# 9610-MPD-4

**STAFF REPORT    City Plan Commission    April 17, 2018    (13)**

**Re:**                            **Case No. 9610-MPD-4:**  
Request to rezone from District R5 (Residential 5) to District MPD (Master Planned Development) and approve a preliminary MPD plan to allow construction of new structures, additions, and parking lots.

**KCAI Master Plan  
Development**  
Kansas City Art Institute  
4415 Warwick Blvd  
Kansas City, MO 64111

**Development Site Summary Table**

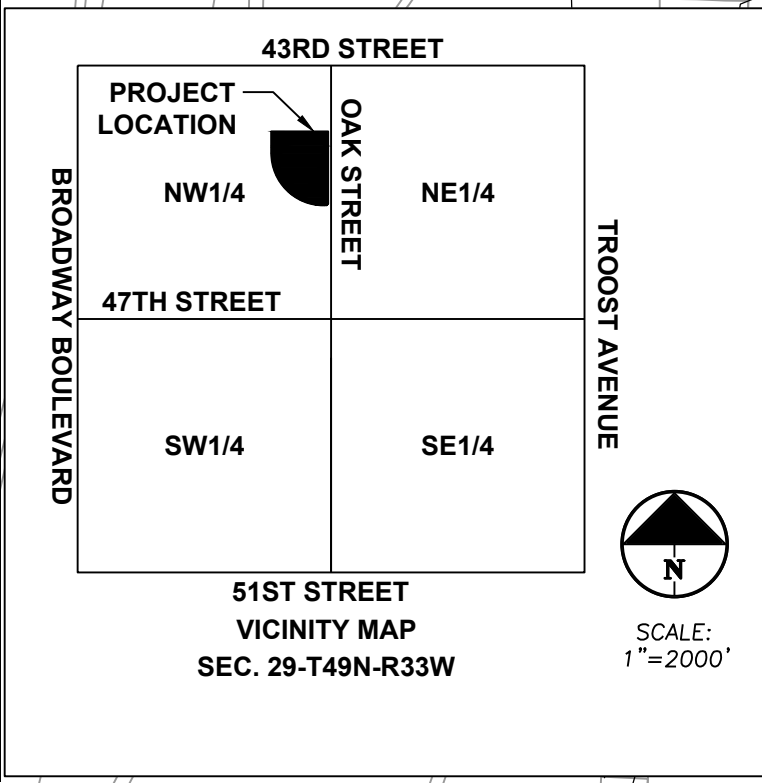
1. That the plan be revised to:
  - a. Revise acreage on Development Site Summary Table (should be 8.68 rather than 12.637, as properties have been removed from the rezoning);
  - b. State, on the plan: “For any final MPD plan submitted to City Plan Commission for review and approval, that the *developer* notify any property owner, any registered neighborhood organization, and/or registered civic organization whose boundaries include the subject property, and all owners of property within 300 feet of the subject property.” (Note: the City is not required to provide notice of project plans.)
